From: Pineda, Christine
To: Fedors, Randall
Subject: Re: eco info
Date: Thursday, June 04, 2015 6:50:42 PM

From: Pineda, Christine
Sent: Thursday, June 04, 2015 1:49 PM
To: Amy Hester (ahester@swri.org)
Cc: Fedors, Randall; Miriam Juckett; David Pickett (dpickett@swri.org); Rubenstone, James
Subject: eco info

From: Pineda, Christine
To: Fedors, Randall
Subject: RE: SEIS, Chapter 2
Date: Thursday, June 25, 2015 12:39:53 PM

Figure 2-1. Boundaries and prominent topographic features of the Death Valley regional groundwater flow system.

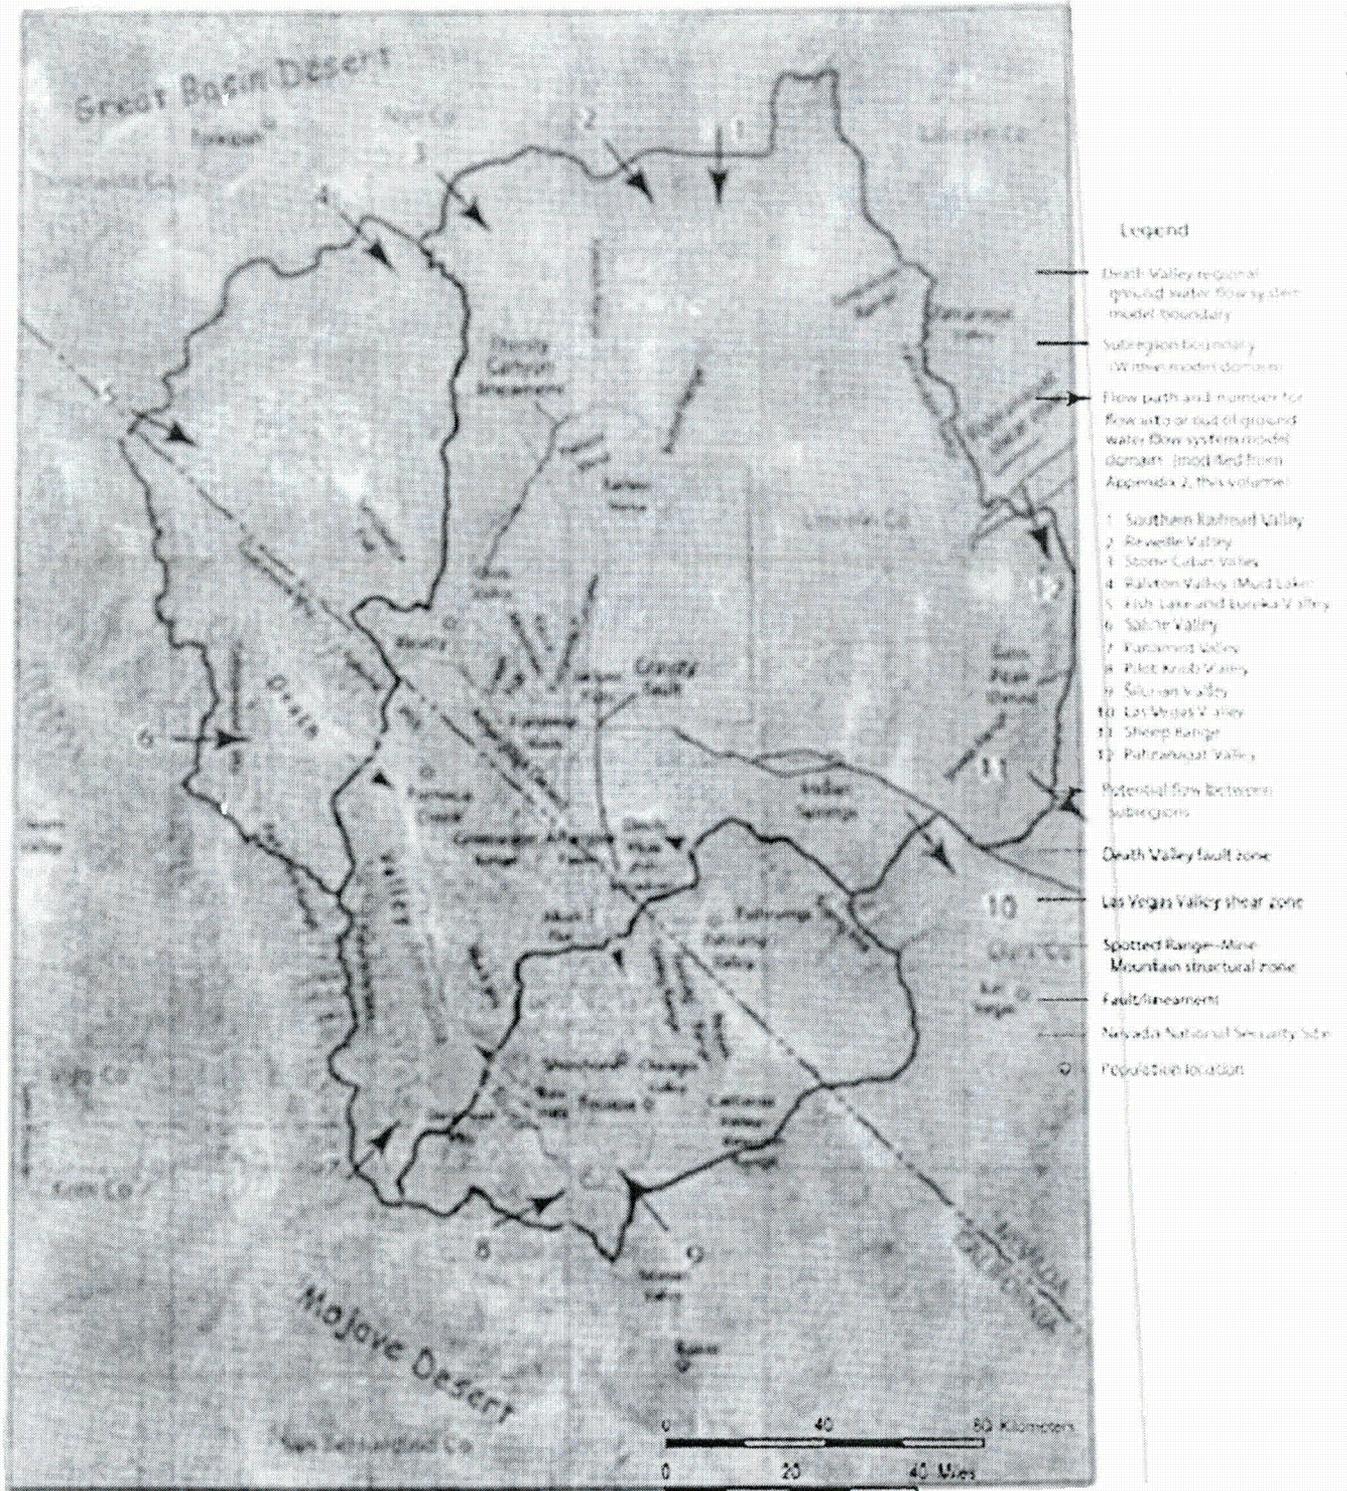
What are we keeping/discarding from Figure 2-1?

UTM coordinates, see BelcherSweetkind to get labeling correct
